Georgetown Charter Township

Planning Commission Meeting Agenda

1. Call To Order
2. Roll Call
3. Approval Of The Agenda
4. Approval Of The Minutes Of The Previous Meeting
5. Old Business
6. New Business
 - 6.I. Site Plan (Revision) – (ST1615) Advanced Interiors – 6656 Pine Ridge Ct.

(ST1615) **Advanced Interiors**, 6656 Pine Ridge Ct., is requesting approval of a revision to an approved site plan to allow a dumpster to be located in a truck well with no screening, on a parcel of land described as P.P. # 70-14-22-477-004, located at 6656 Pine Ridge Ct., in an (I) Industrial district, Georgetown Township, Ottawa County.

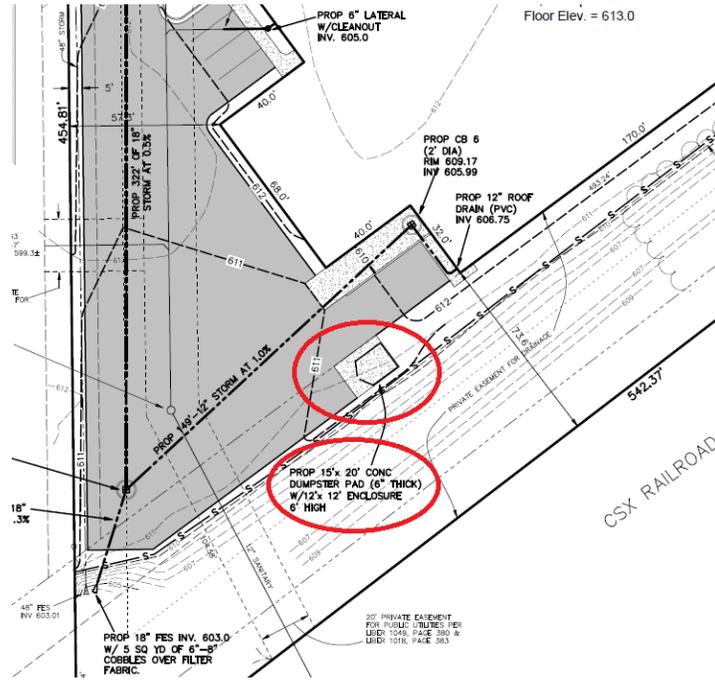
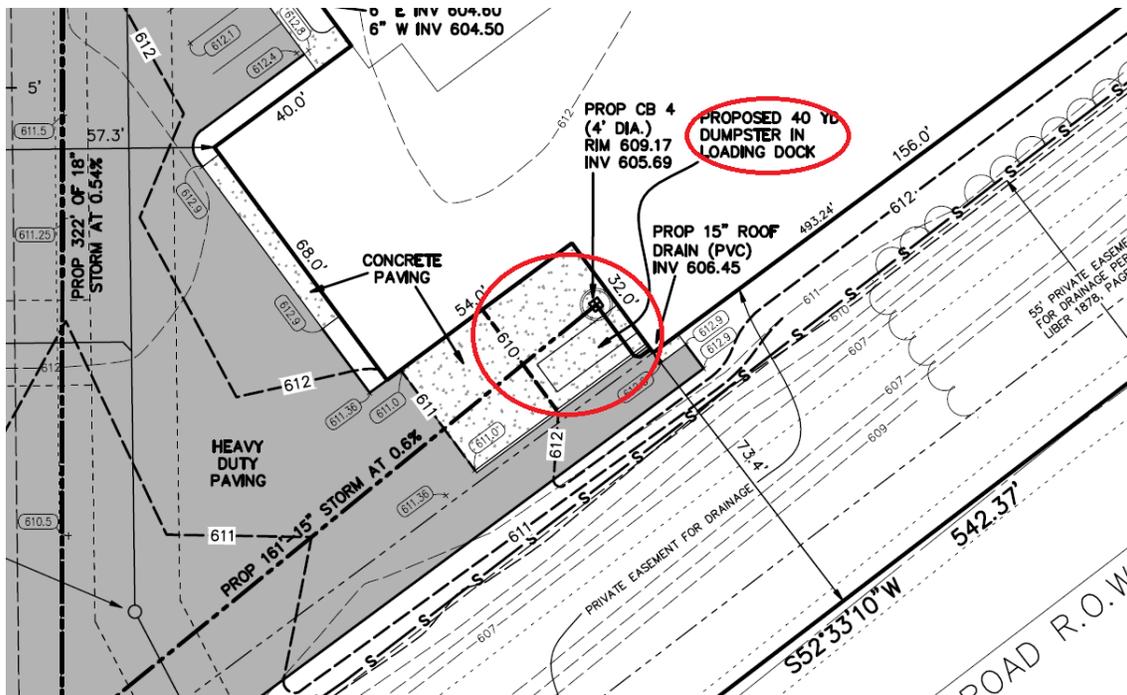
At the November 5, 2014 meeting, the Planning Commission approved a special use permit and site plan showing the dumpster to be located on a cement pad and enclosed with a six foot high fence.

The request is to locate the dumpster in the truck well and to have no screening.

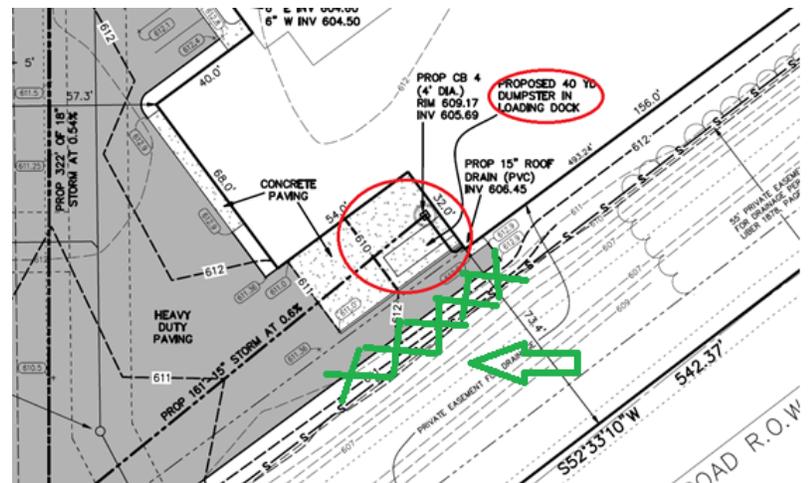
Although the Zoning Ordinance gives the Zoning Administrator the authority to approve site plans and to approve minor changes, the determination was made that this change should return to the Planning Commission since the Planning Commission initially approved the site plan that was part of the Special Use Application. Further, the approved the site plan with the dumpster on a cement pad and with screening, was based on the language in the ordinance. Therefore, the Planning Commission should determine if the new location is appropriate and if it should be allowed with no screening.

The Zoning Administrator offered to approve the new location with screening (either six foot high fencing or landscaping) to be added along the outside of the lane as shown in the drawing above. However, the applicant stated that the area is not visible from Chicago Dr. due to a berm that is covered with weeds that screens the site and is, therefore, requesting no screening.

1. Is the location of the dumpster acceptable in the truck well?
2. If yes, should the area be screened (on the Chicago Dr. side of the interior lane) with either six foot high fencing or landscaping?

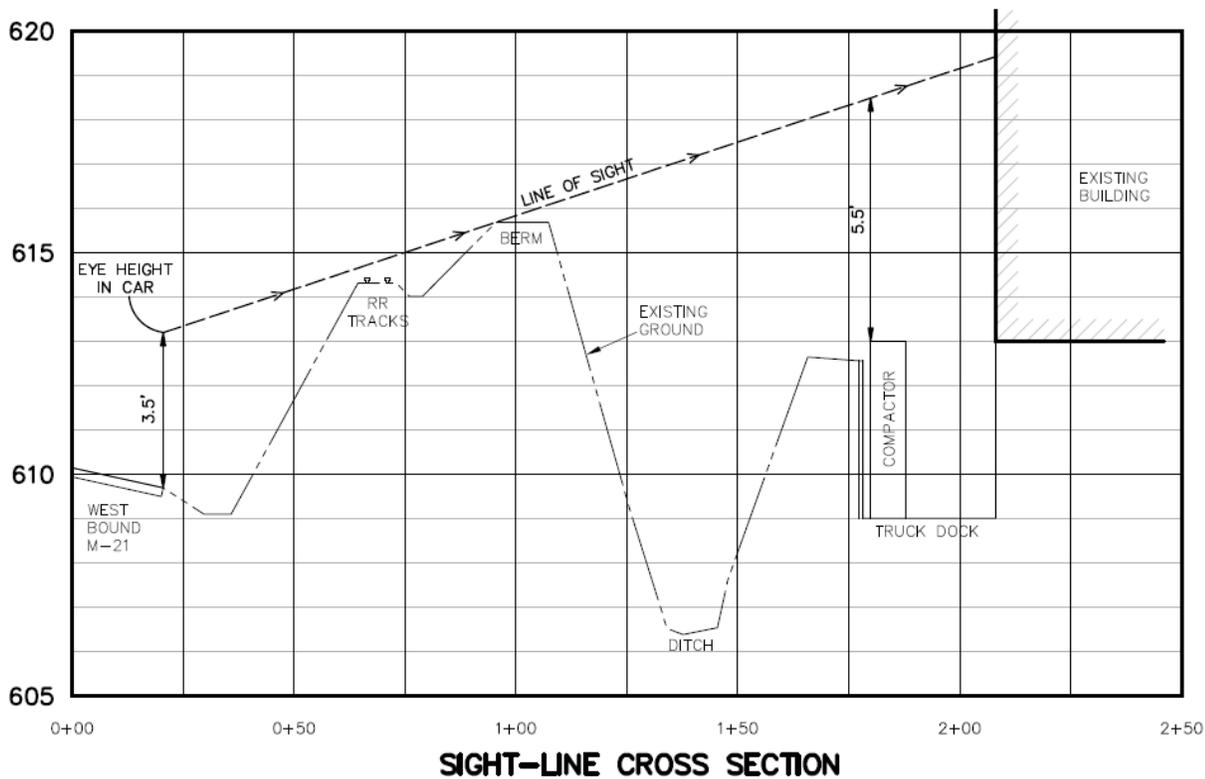
Below is the line of sight submitted by the applicant.
